## Service information

Reference no.: SDA\_106090

Expresia Watery Coffee

picture1

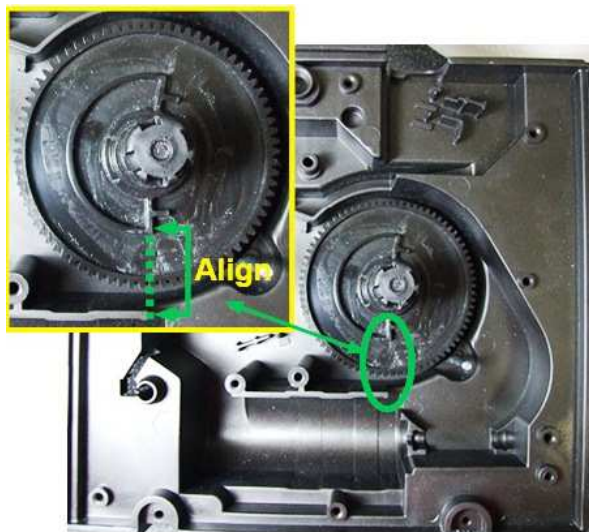
**1. pn.11007137**: gear correction

picture2

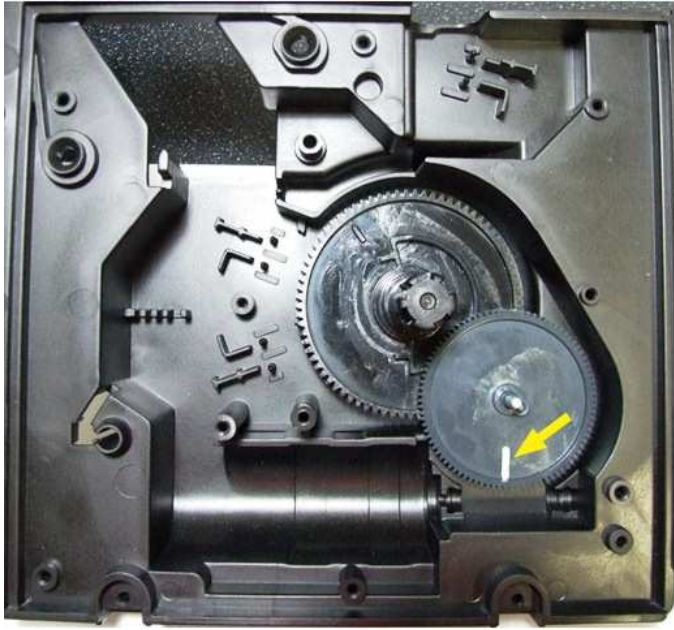
**2.** The gear, **pn 14002800**, has to be the one with "2" printed on the top (**see picture nr 2**). Make sure you have the right part, otherwise, order the **kit 421941307001**

picture3

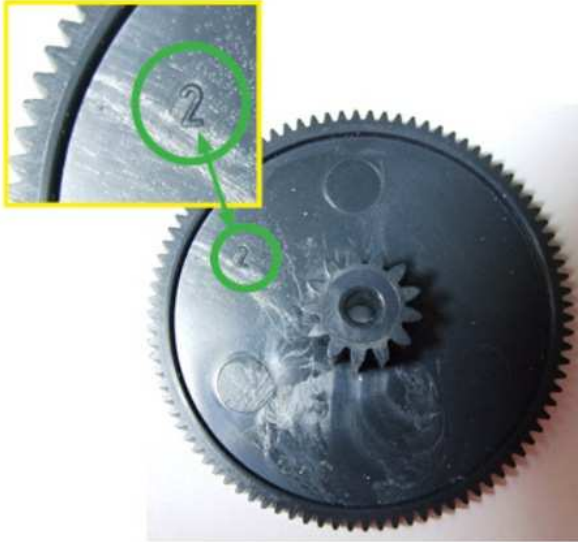
**3. Pn 146002800:** gear correction.
